Permit #: 71**Permit Date:** 06/01/23**Permit Type:** Planning Commission**Case Number:** PC 23-26**PC Meeting Date:** f. 1st Tuesday of July**BZA Meeting Date:****Assigned Meeting Date:** 07/06/2023**Special Meeting Date:****Applicant Is:** Engineer**Applicant Name:** Preston Ayer**Applicant Address:** 504 Autumn Springs Ct #6**Applicant City, State, ZIP:** Franklin, TN 37067**Applicant Phone Number:** 951-704-0890**Applicant Email:** bids.urbandg@gmail.com, bids.urbandg@gmail.com**Description:** Proposed single family dwelling on a steep slope**Project Cost:** 1250**Square Feet:** 0**Lot Area:** 0**Lot Coverage:** 0**Heat/cooled area:** 0**Proposed Height(ft.):** 0**#of stories:** 0**Lot Depth/Width Ratio:****Avg. front setback of adjacent homes:****Zoning District:** Zone D**Radnor Lake Impact Zone:** No**Steep Slope:** Yes**Plat/Subdivison:** No**Status:** Open**Assigned To:** Desiree Lohr**Property**

MEMORANDUM

To: Mr. Stephen Snow
From: Zac Dufour, P.E.
Kimley-Horn and Associates, Inc.
Date: May 9, 2023
Subject: PC Case 22-18, 5425 Franklin Road

DETAIL #1 - ENTRANCE DRIVE

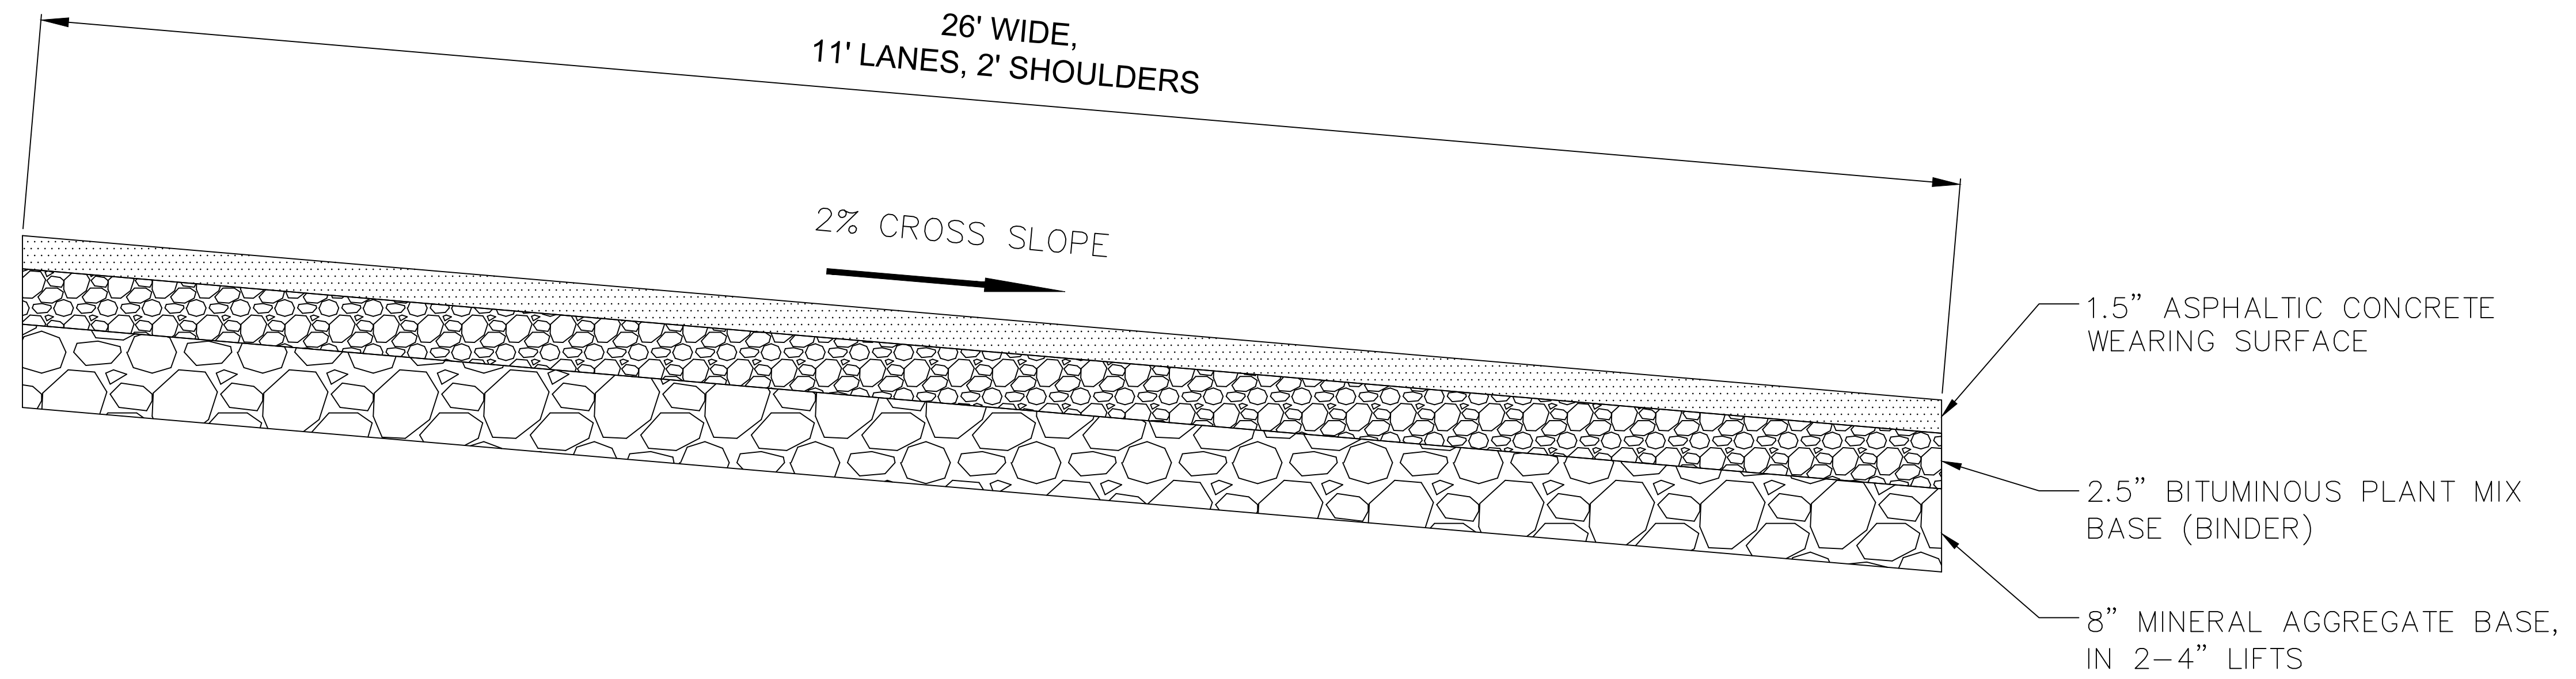
- 16. Private road must comply with Oak Hill Subdivision regulations (street section, slopes, pavement design, etc.) – 11' lanes and 2' shoulders. TDOT detail will not suffice. Provide updated drawings and details for cross section and pavement designs.

- a. **Proposed drive configuration meets requirements agreed to in city meeting.**
- 17. Have landscape architect provide planting plan for rain garden.

DETAIL #1 - 5425 BIORETENTION POND

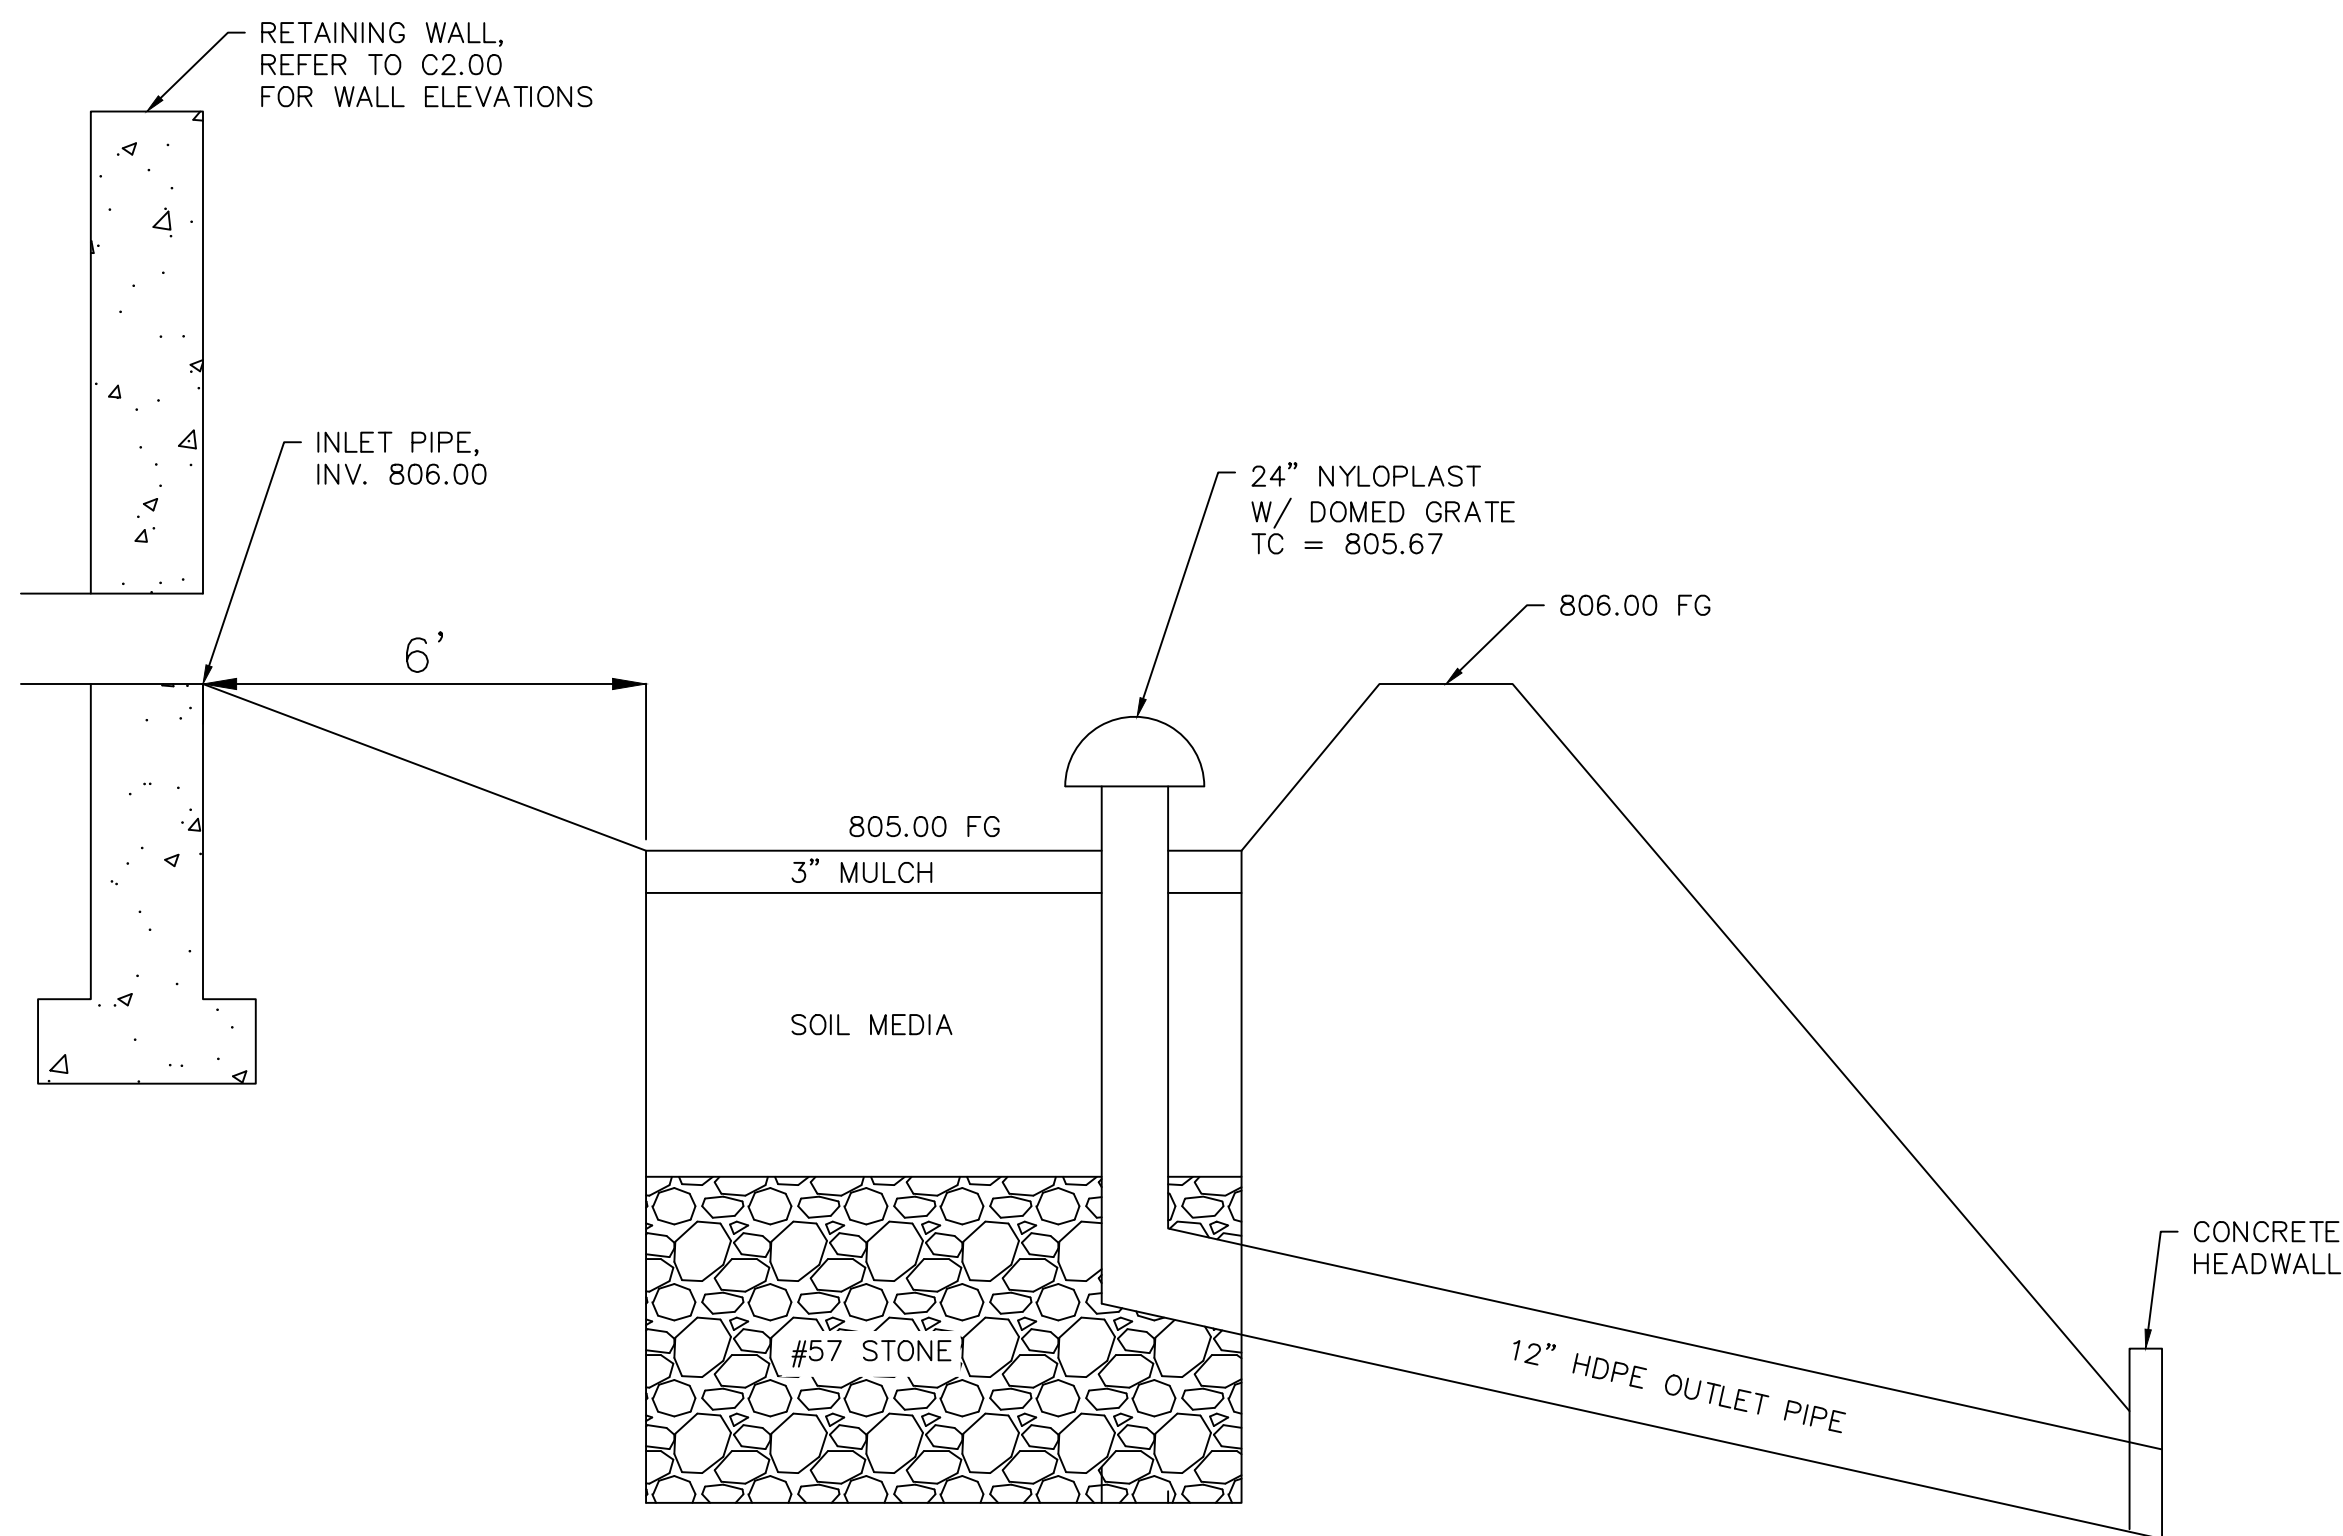
- a. **Due to high infiltration rates, underdrains no longer required.**
- 14. Provide more detailed elevations for rain garden specific to this site with a site-specific section detail of the rain garden with elevations, inverts, section thickness and materials.

DETAIL #3 - TRENCH BACKFILL

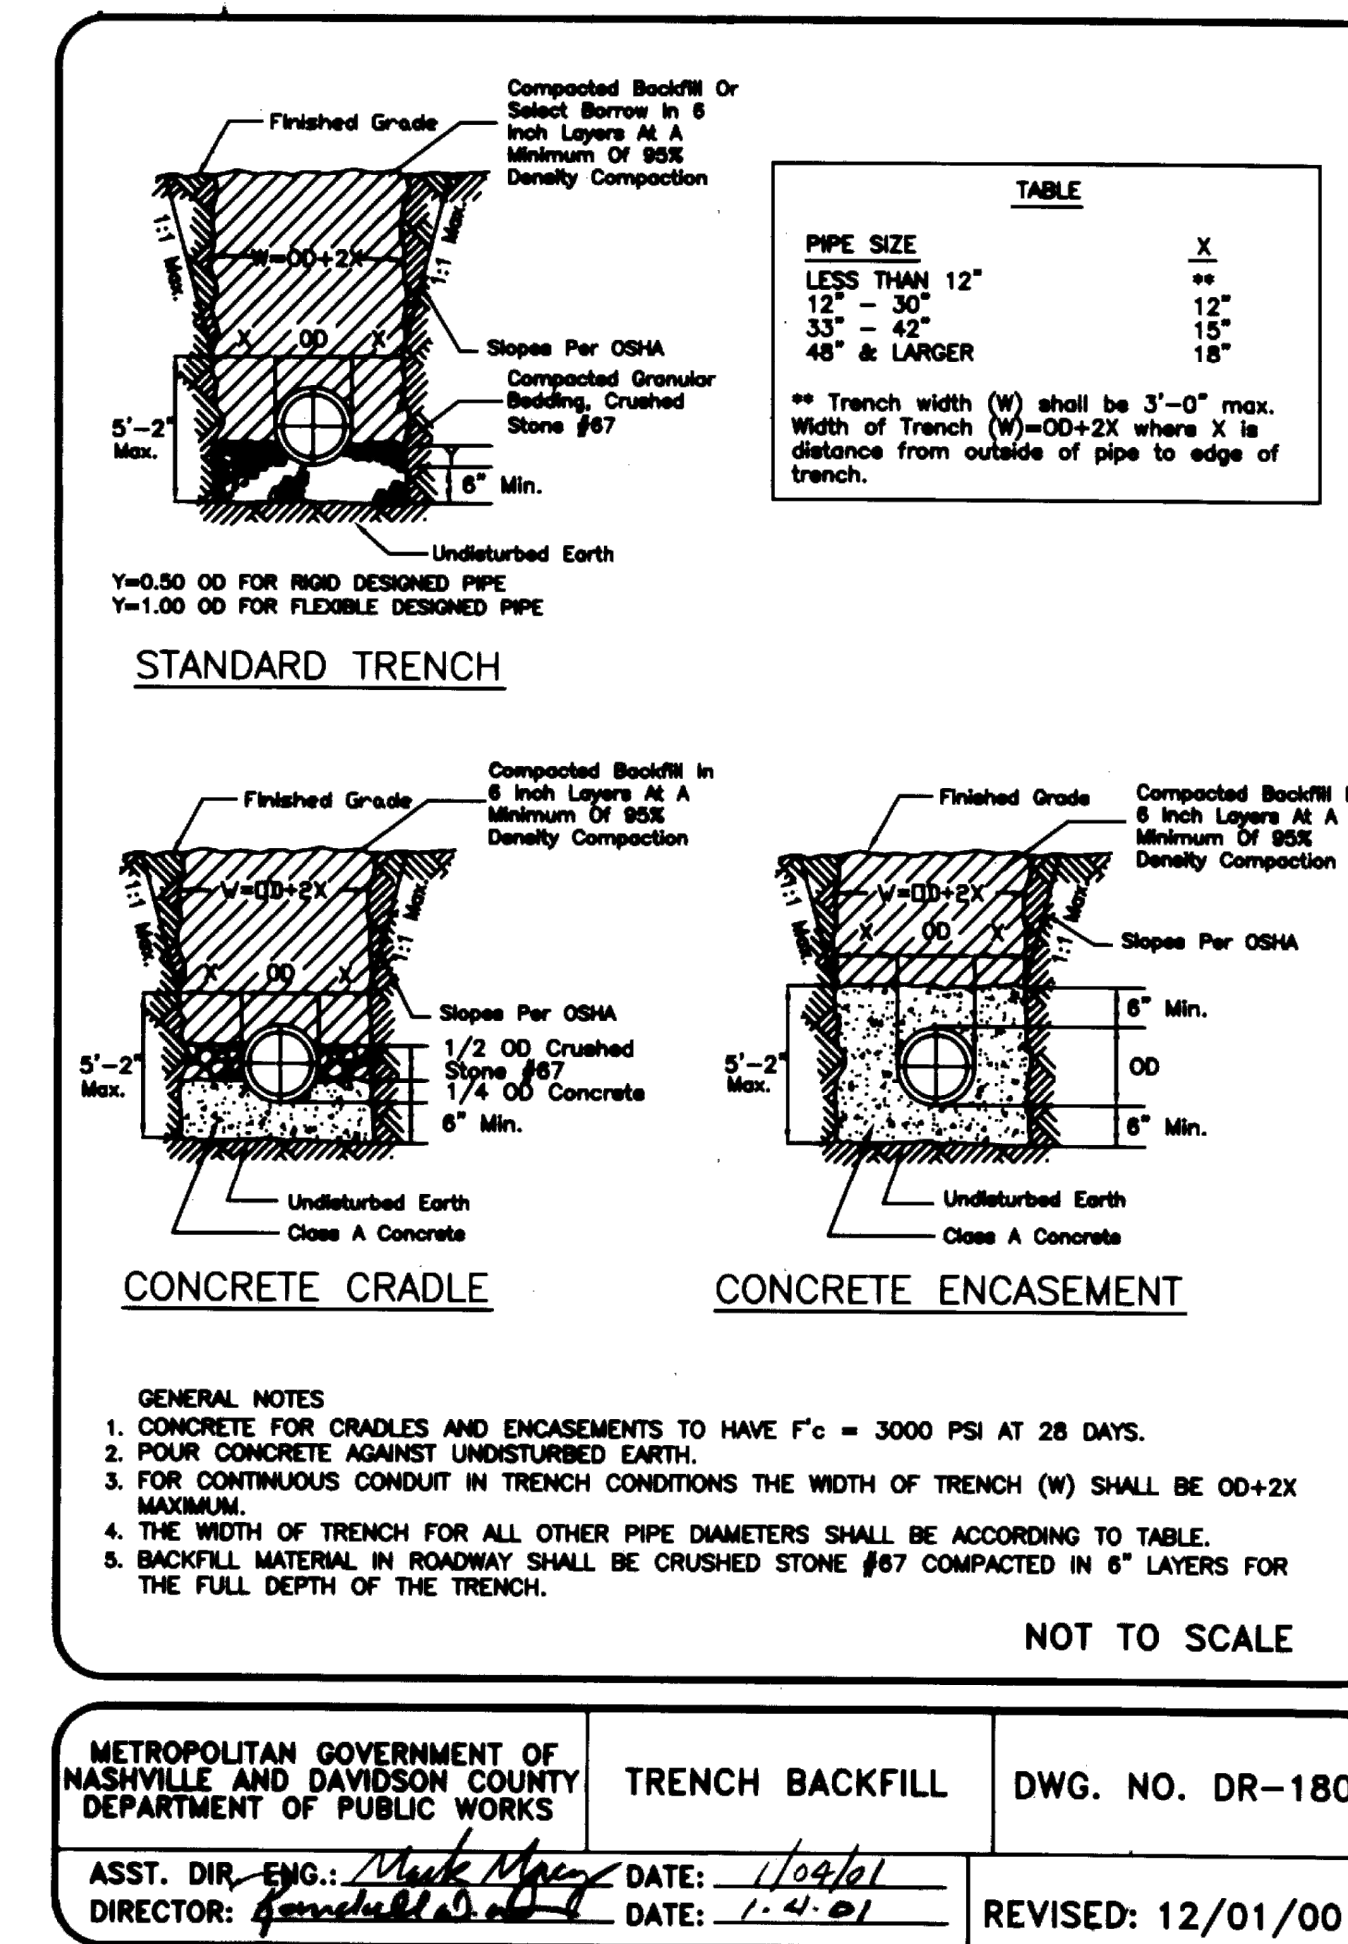
MISSING NDOT DETAIL ST-322 IN PLANSHEET

- a. Easement documents pending. Easements will be recorded prior to PC
- 12. Provide TDOT permit for work within the ROW.
 - a. TDOT deferred to NDOT. NDOT asked to provide ST-322 Drive Apron detail. Detail not provided in plan. Detail Added.
- 13. Is the water line connection within the roadway? Detail referenced is for asphalt repair, but the detail shown is for trench repair outside of asphalt. Clarify.
 - a. Clarified.
- 14. Some base information is missing on the landscape plan.
 - a. Provided.
